Re: PA22-044 – Olympic Vista PRD – Technical Review 1
4128 Sunnyside Blvd. APN 29050300102200

After preliminary review of the above referenced proposal, the Planning Division has the following comment(s):

RE: Olympic Vista PRD, File# PA22-044
23 lot PRD subdivision
4128 Sunnyside Blvd. & Parcel # 29050300102200

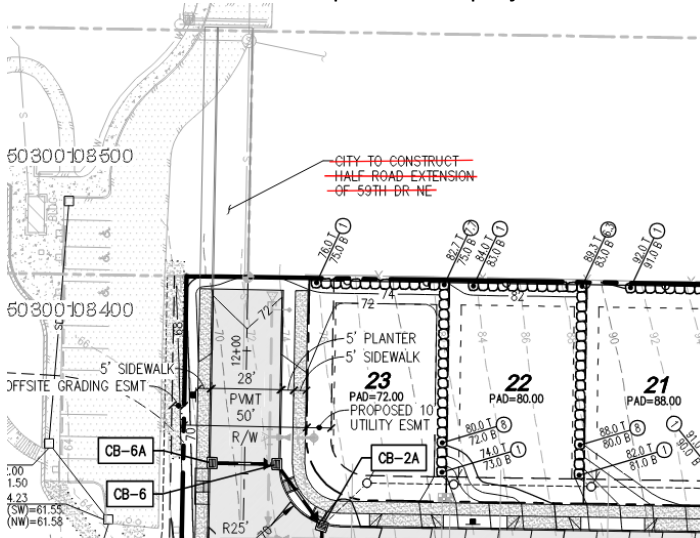
Tall retaining walls must be terraced with landscaping as depicted below.
